## Design & Construction Field Bulletin

Date	June 6, 2016 (Issuance #002)
Field Bulletin No.	FB-005 2016 (1 pages)
Category	Kitchen Equipment
Subject	Exhaust Hood Canopy (Tag F-71)
Prototype Set Referenced	PLK 15 Series Drawings
Prototype Drawings Referenced	Sheets K1 & K2a
D&C Contact	design@popeyes.com

**1 EQUIPMENT PLAN**  
K1 1/4"=1'-0"

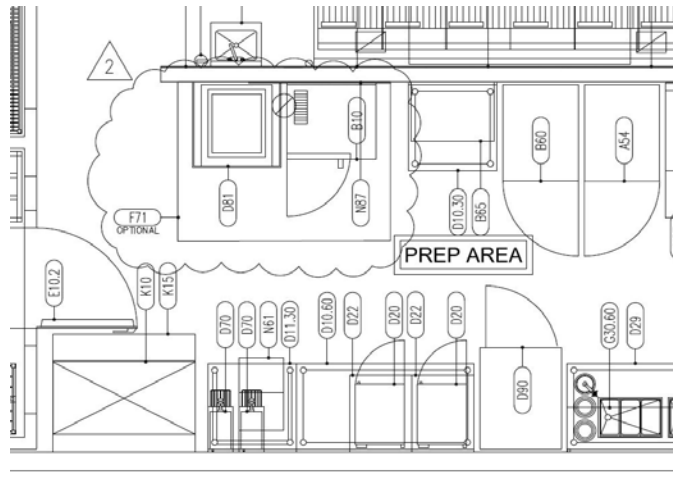
Some of the franchisees' architects and engineers are including the exhaust hood above the Biscuit Holding unit and the Double Deck convection oven as a part of their standard kitchen equipment list. This hood should be listed as "Optional", because not all jurisdictions require a hood above these pieces of equipment.

**F71 Exhaust hood (Optional)**

Refer to the kitchen equipment sheets for the change in the need of the hood to "Optional".
